Access Compliance Report

Public Rights-of-Way

(Curb Ramps)

Intersection ID: 42765	Main Street: CRUTCHFIELD_PL	Cross Street: WINSTON_OAKS_CT	Location: NE
ADA ID: 0835CBEB0592	Ramp Type: PerpDiag	Initial Pass/Fail: Fail	Overall Compliance: No
Severity Score: 22.5			
Codes/Mitigation Info/Possible Solution		Field Measurements/Component Compliance

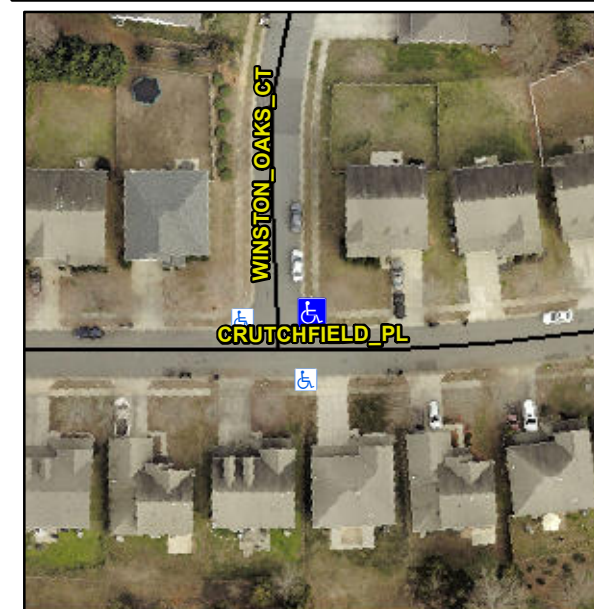
Not Found, R304.5.1, R304.2.2, R304.5.3

Compliance	Description	Data	Compliance	Description	Data
N/A	Ramp Length (in)	51.0	No	Ramp Slope (%)	9.9
No	Ramp Width (in)	40.0	No	Ramp XSlope (%)	2.1
N/A	Flare Type LT	N/A	N/A	Flare Type RT	N/A
N/A	Flare Slope LT (%)	N/A	N/A	Flare Slope RT (%)	N/A
N/A	Flare Traversable LT?	N/A	N/A	Flare Traversable RT?	N/A
N/A	Landing Length (in)	N/A	N/A	DWS Provided?	N/A
N/A	Landing Width (in)	N/A	N/A	DWS Contrast?	N/A
N/A	Landing Slope (%)	N/A	N/A	DWS Length (in)	N/A
N/A	Landing X Slope (%)	N/A	N/A	DWS Full Width?	N/A
N/A	Landing Curb? (Y/N)	N/A	N/A	DWS Offset (in)	N/A
N/A	Shared Landing?	N/A			
N/A	Gutter Ponding?	N/A	N/A	Gutter Slope (%)	N/A
N/A	Gutter Lip Ht (in)	N/A	N/A	Gutter X Slope (%)	N/A
N/A	Painted X Walk1?	No	N/A	Painted X Walk2?	No
	X Walk 1 Direction	To W		X Walk 2 Direction	To S
N/A	X Walk 1 Width (in)	N/A	N/A	X Walk 2 Width (in)	N/A
	X Walk 1 Slope (%)	8.9		X Walk 2 Slope (%)	9.5
	X Walk 1 X Slope (%)	1.0		X Walk 2 X Slope (%)	5.8

Remove & Replace Curb Ramp With Two New Directional Ramps or Equivalent.
